**HMC ARCHITECTS
3546 Concourses Street
Ontario, California 91764**

Arvin High School ESSER III Phase 1 Roofing

Kern High School District

File No: 15-H3 A#03-122508

WALL PARAPET FLASHING 8
3" = 1'-0"

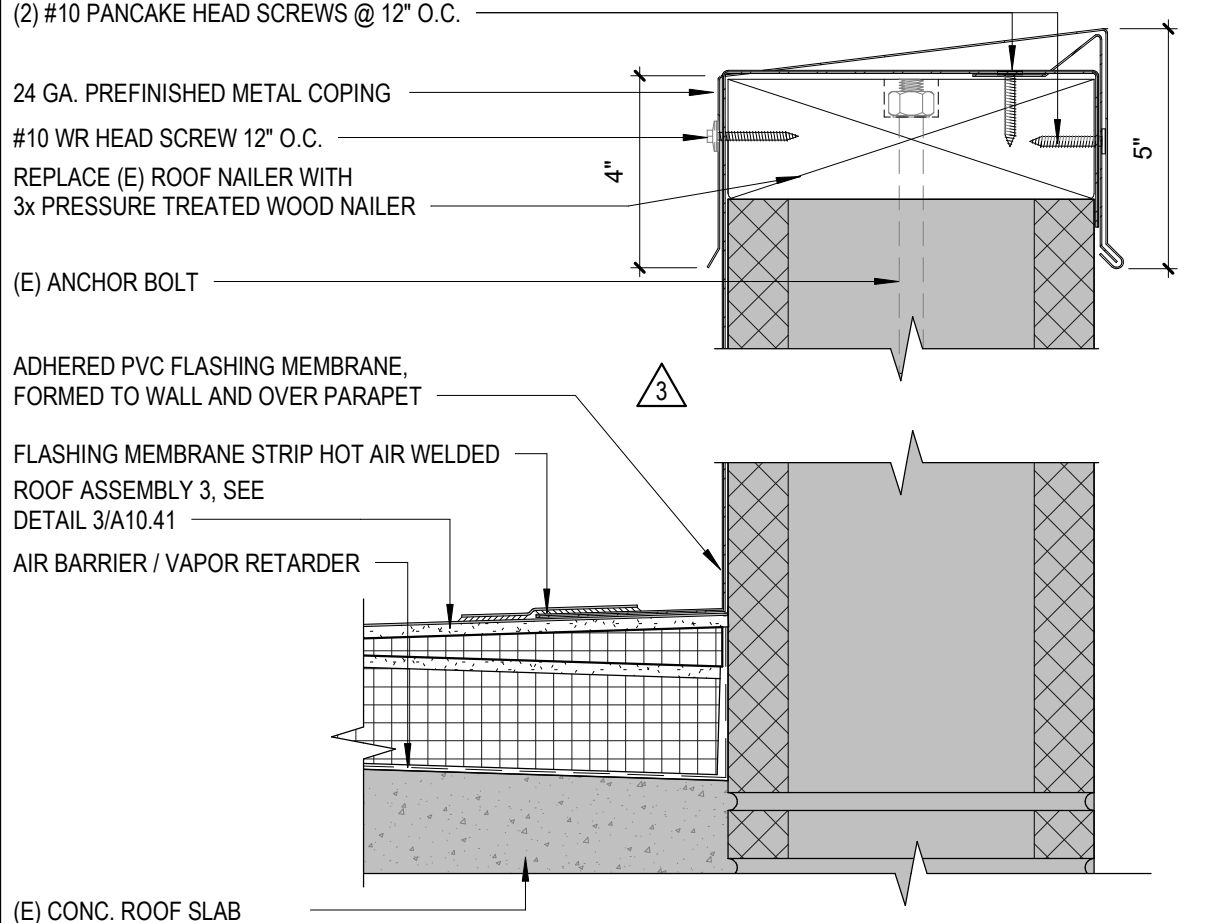
- 1.) DELETE cant strip as shown and clouded per Delta 3.
- 2.) MODIFY PVC Coated metal flashing to Adhered PVC Flashing Membrane on Detail 8, 9, 10, 14, 19, 21 & 23 as shown and clouded per Delta 3.

A4.30 BUILDING 2A & 2B – ROOF PLAN – DEMO. Dated 2023.09.18

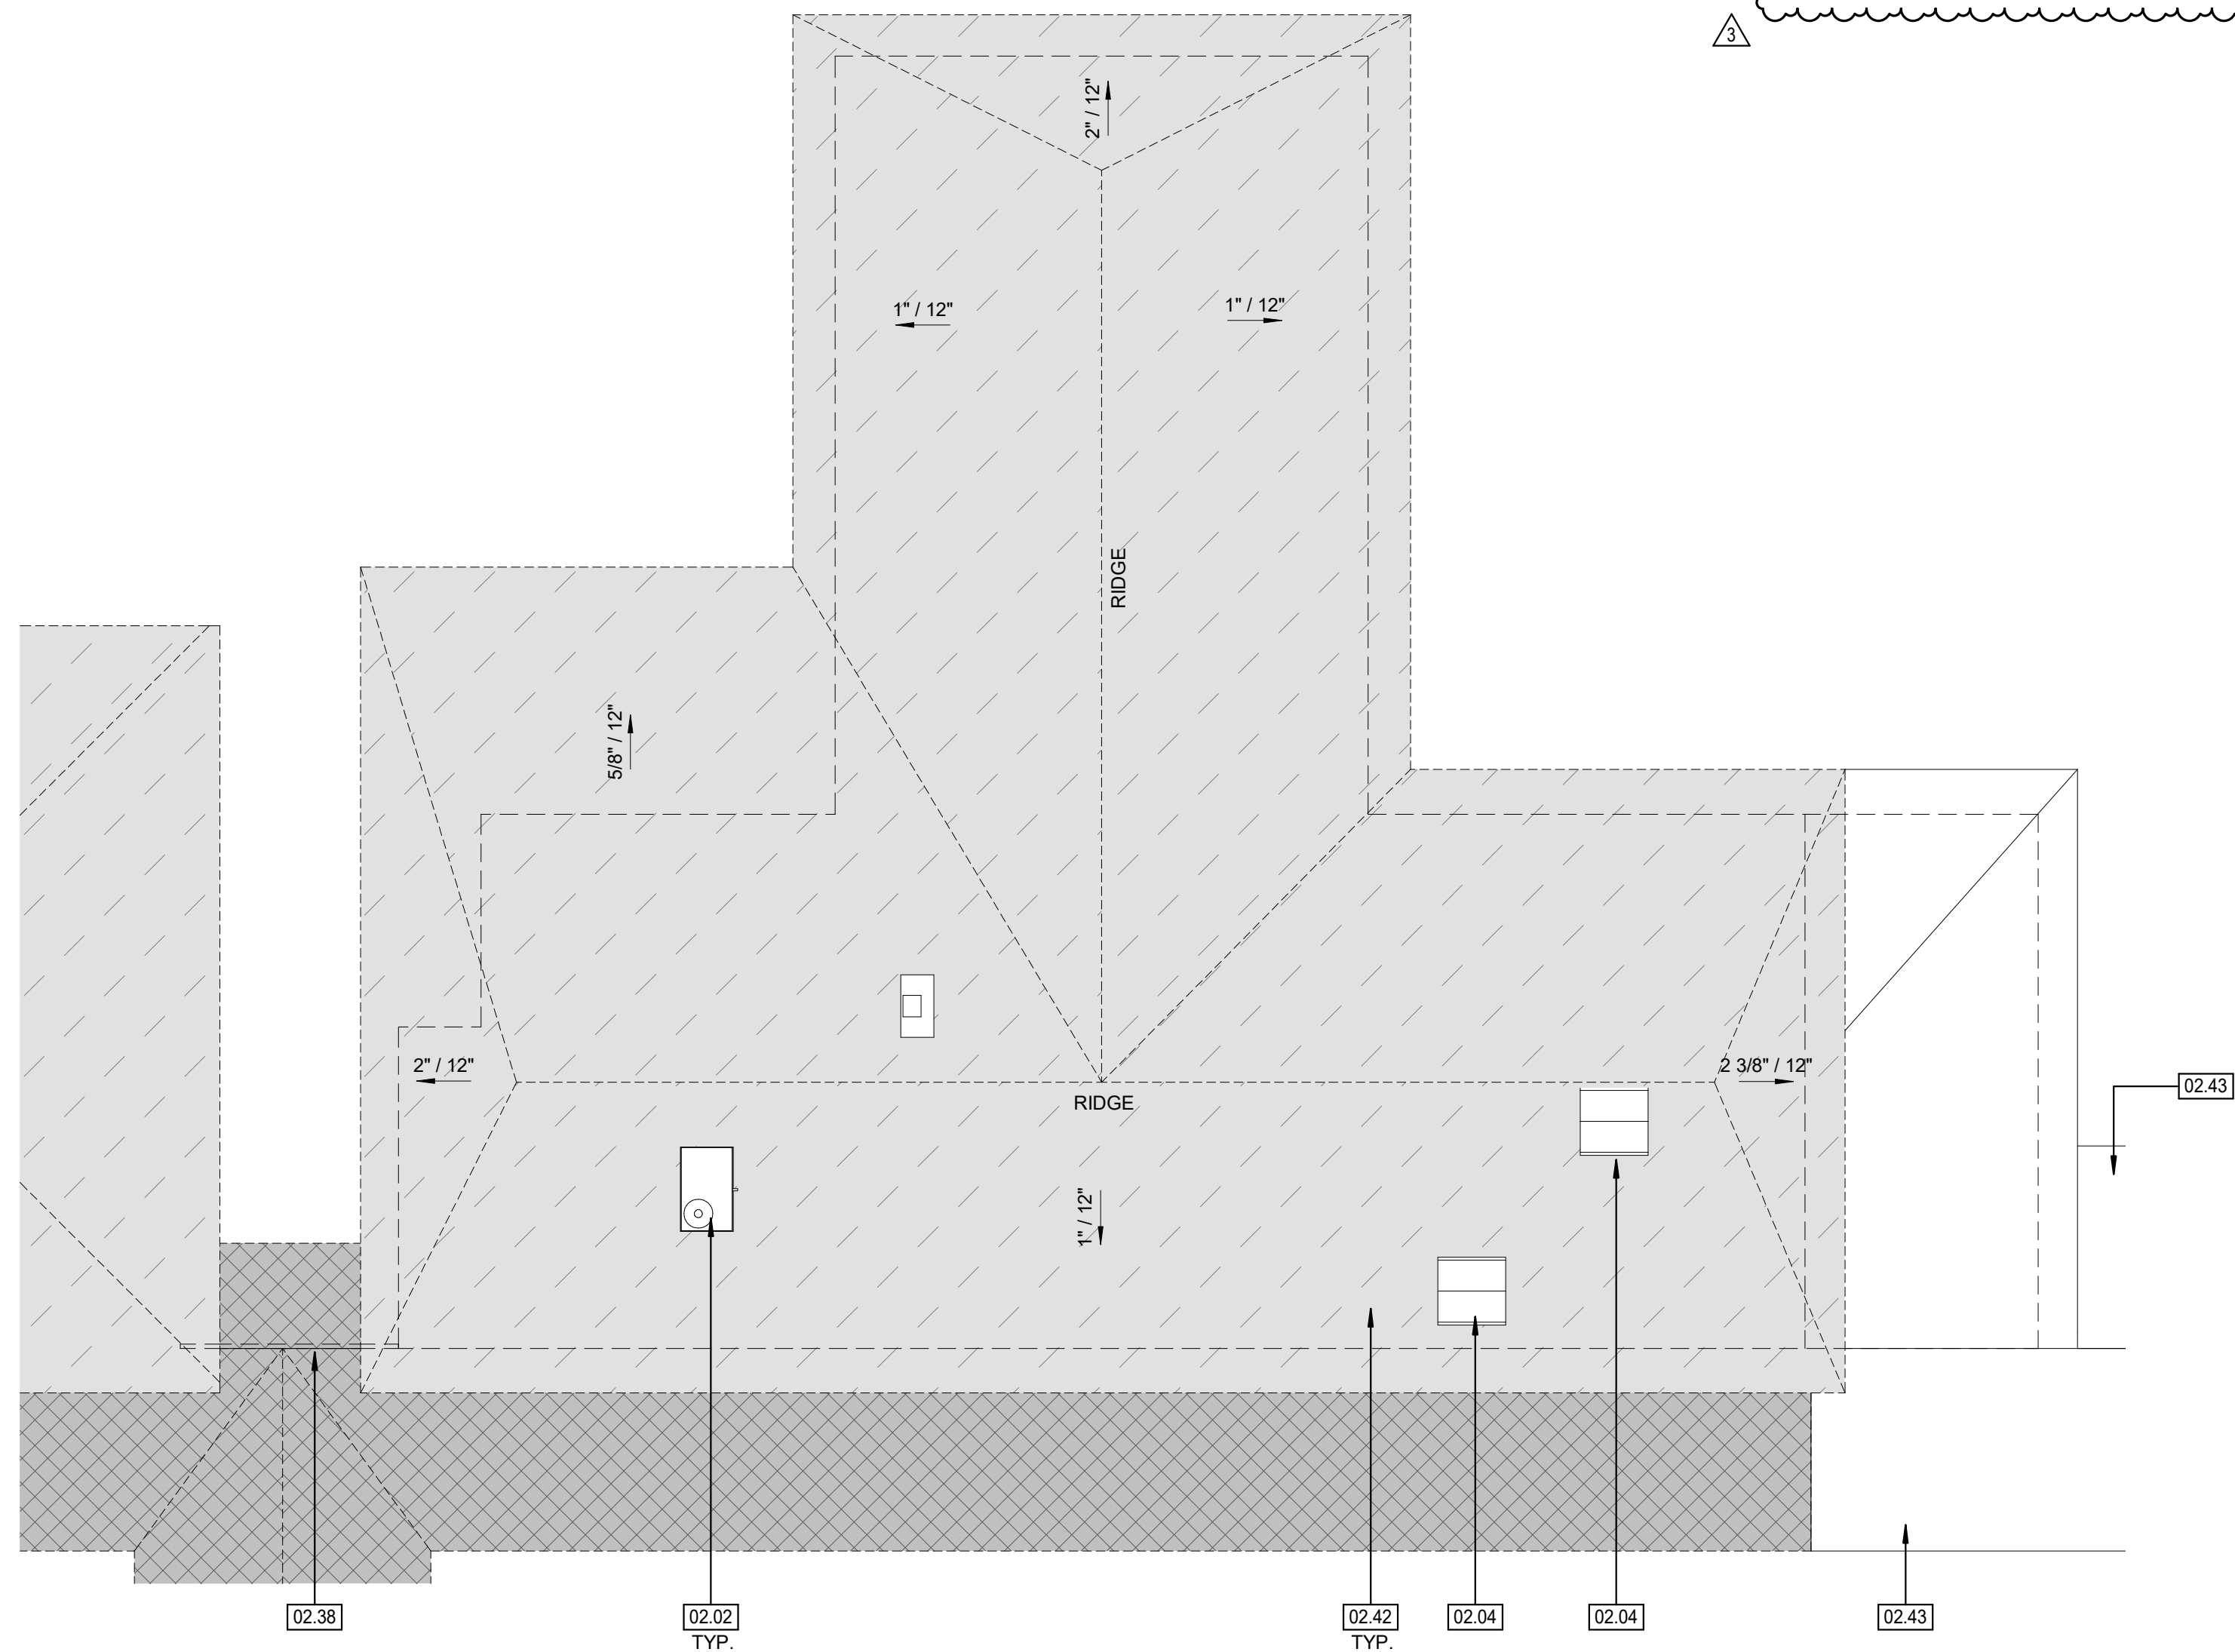
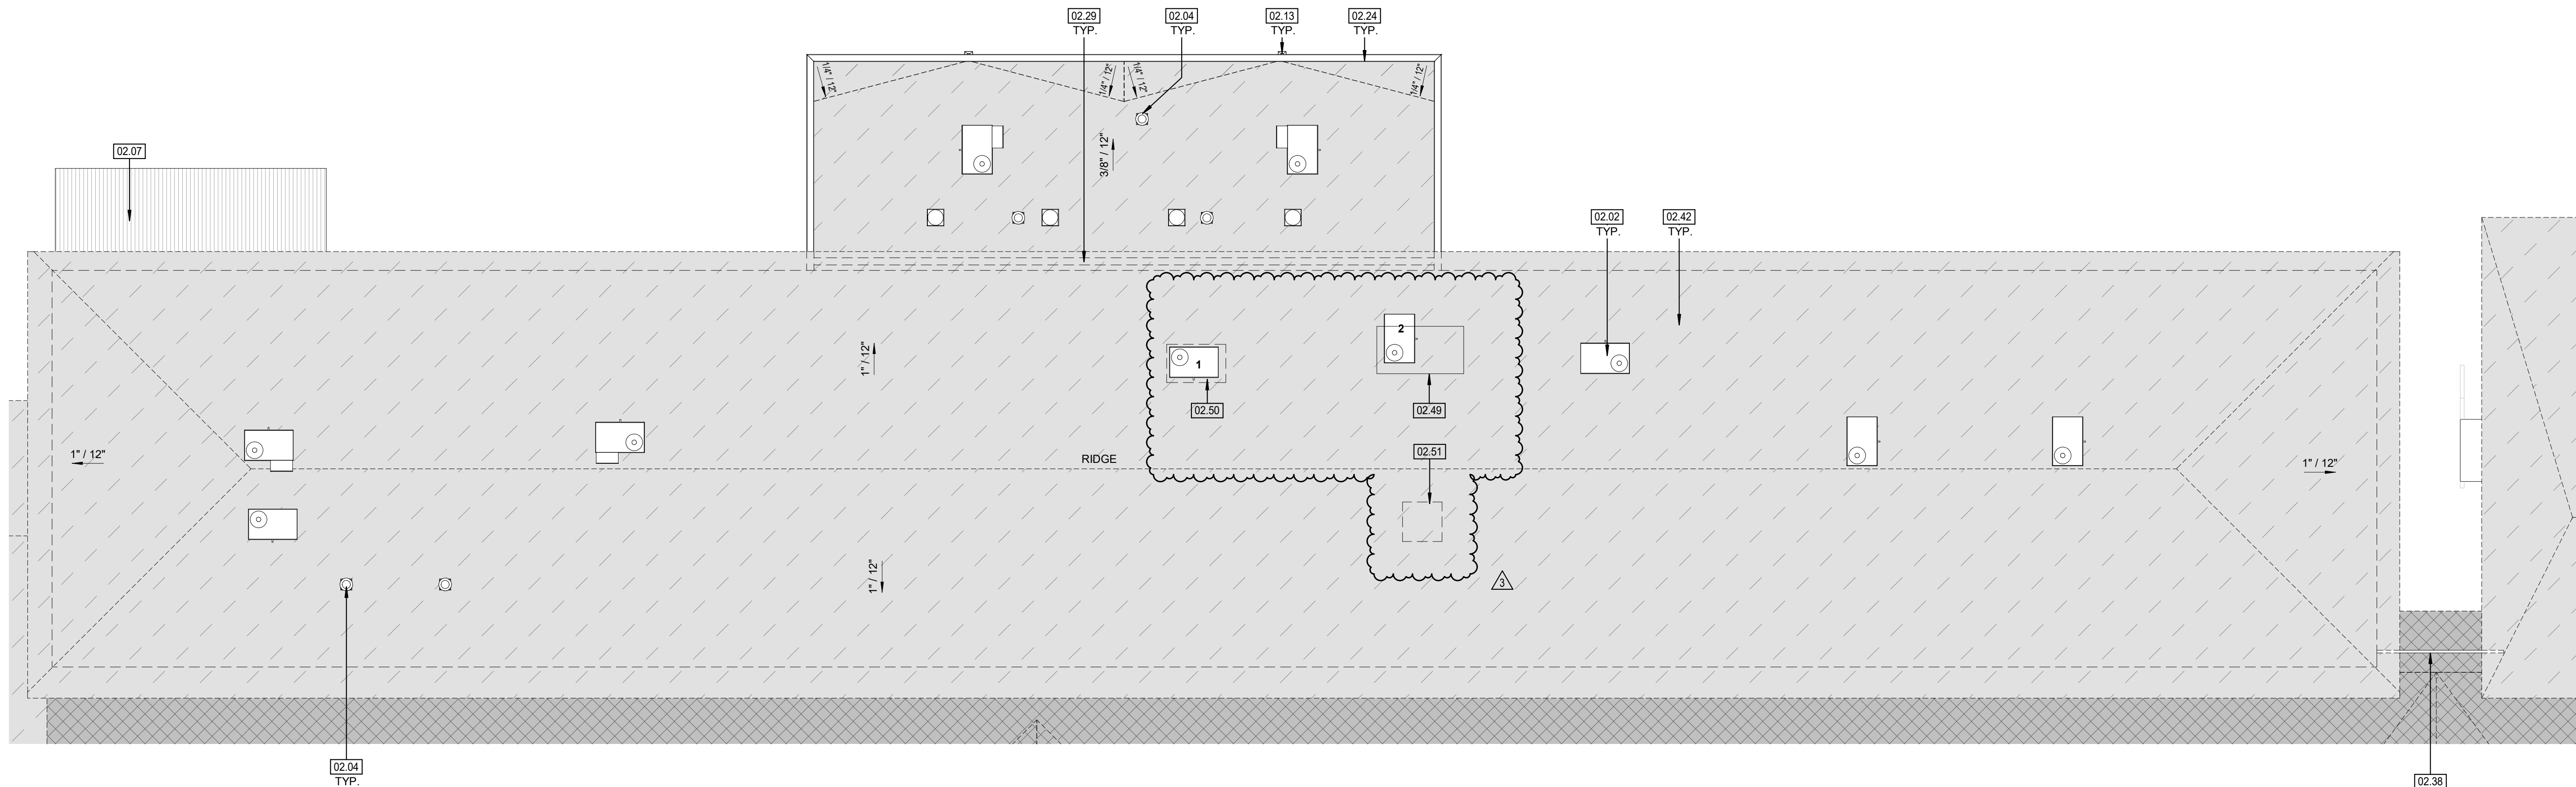
- A. At Keynotes, ADD Keynotes 2.49, 2.50, and 2.51 as noted and clouded per Delta 3.
- B. At 1/A4.30 - Building 2A - Roof Plan - Demo, ADD Keynote References as shown and clouded per Delta 3.
